California ISO

**Clean Energy and Pollution  
Reduction Act  
Senate Bill SB350 Study**

**Stakeholder Comment and  
ISO Responses from  
May 24 – 25, 2016  
Preliminary Results Meeting**

**July 12, 2016**

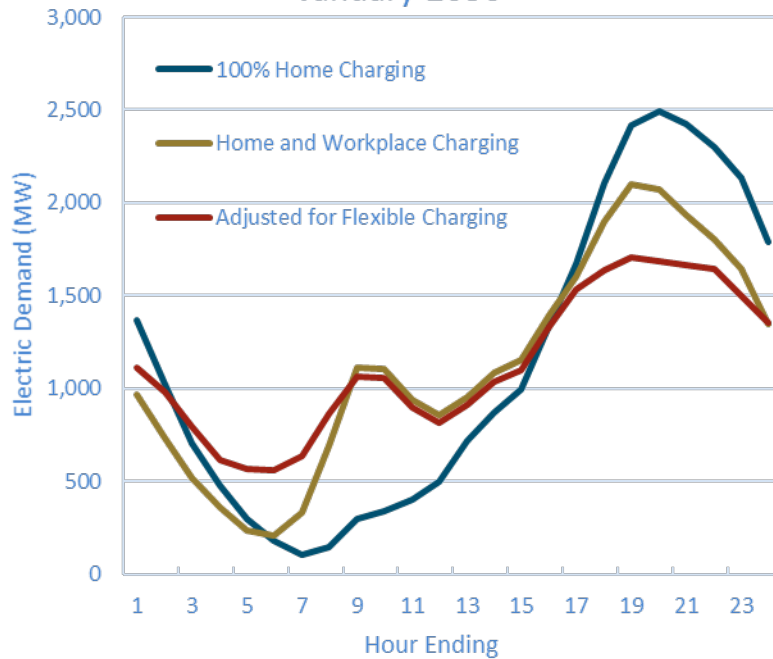
3. What is the effect of workplace charging stations modeled (e.g., quantity and timing of shifted load, or provision of ancillary services)?

In PSO, time of use impacts on the annual peak and energy forecast are included based on the CEC's load forecast.

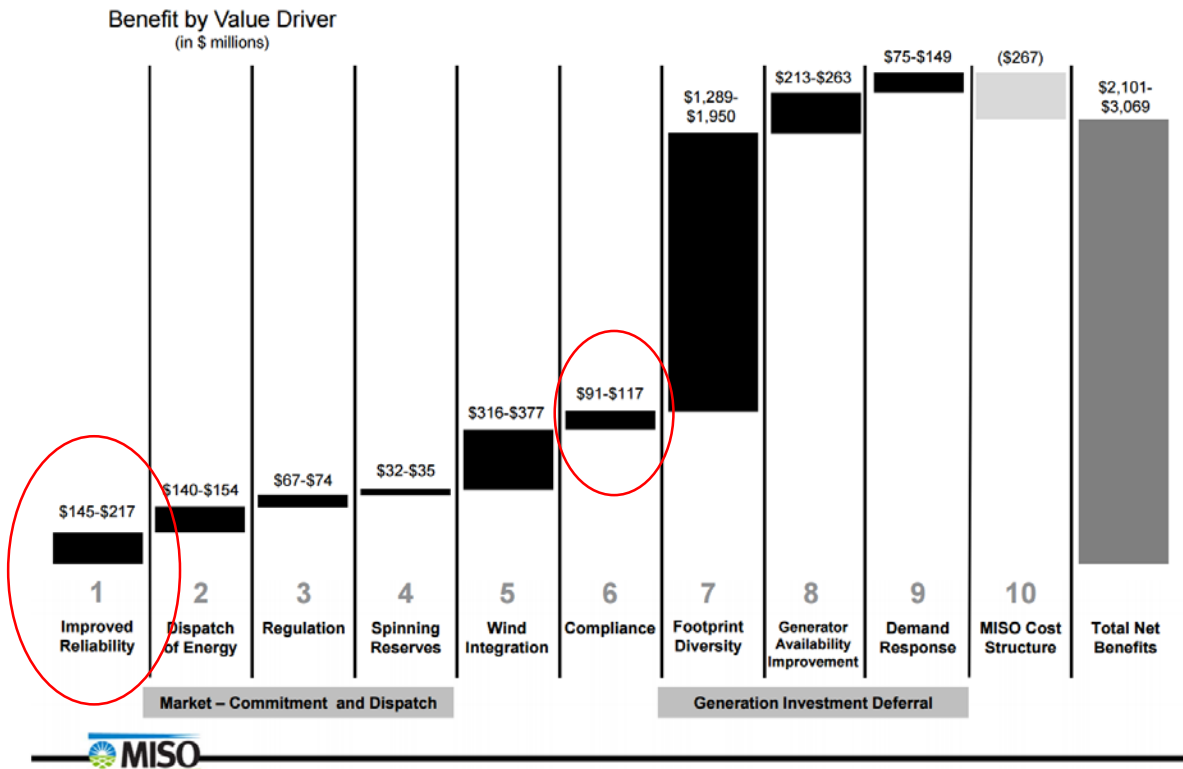
Row 1.1: See [Federal Energy Regulatory Commission staff paper Qualitative Assessment of Potential Reliability Benefits from a Western Energy Imbalance Market](#), 2/26/2013 and Appendix E from the CAISO May 24 SB 350 study results slides. Our estimate of the unquantified system reliability benefits (\$0-\$10 million each for California and PacifiCorp in the ISO+PAC 2020 scenario and \$10-\$50 million for California and \$50 million+ west-wide in the 2030 scenarios) may be conservative given MISO's experience. The graph below from [MISO's 2015 Value Proposition](#) shows reliability benefits of between \$145-\$217 million.

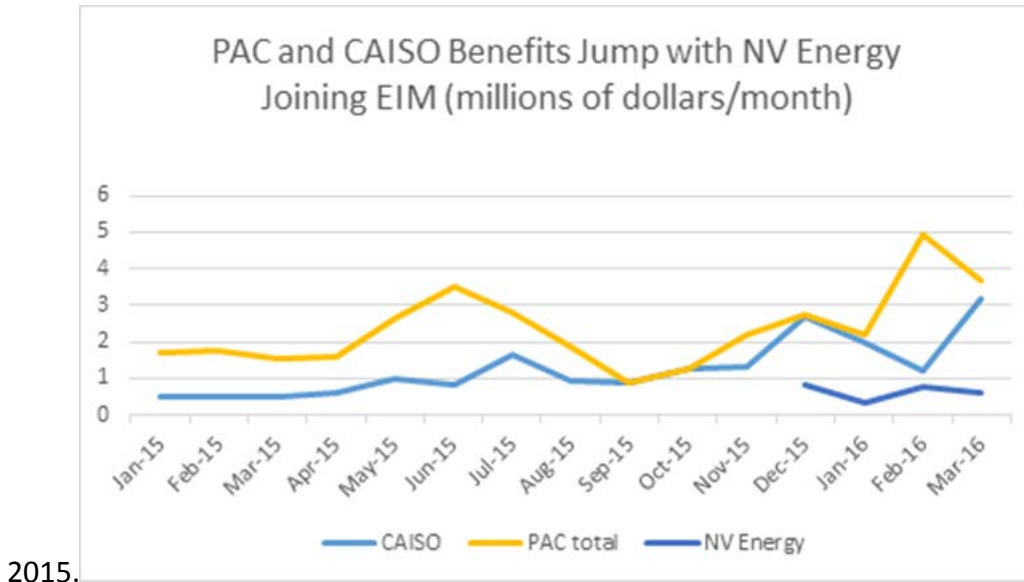
Row 2.1: The assumed limits on transfer capacity between CAISO and PacifiCorp (776 MW) do not reflect the possibility that other utilities (e.g., NV Energy) would join the RSO. Just adding NV Energy to the RSO would increase transfer capacities from the CAISO by more than 4,000 MW, even without construction of many proposed big projects that would vastly increase transfer capacity (e.g. TransWest Express, Cross-Tie, Gateway, Zephyr, and LS Power's SWIP North). This potential increase in PAC and CAISO benefits from NV Energy participation is illustrated in the graph below, which shows

benefits increased when NV Energy joined the EIM in December

Therefore, we believe the CAISO/PacifiCorp scenarios underestimates benefits of an RSO by more than \$10-50 million annually in the 2020 scenario (and by a greater amount in 2030). We assume the study results accurately capture the value of increased transfer capacity in the west-wide scenario. The benefits of increases in transfer capacity have been found when other RSO were formed. ([Summary of Other Regional Market Impact Studies](#), p. 13.)
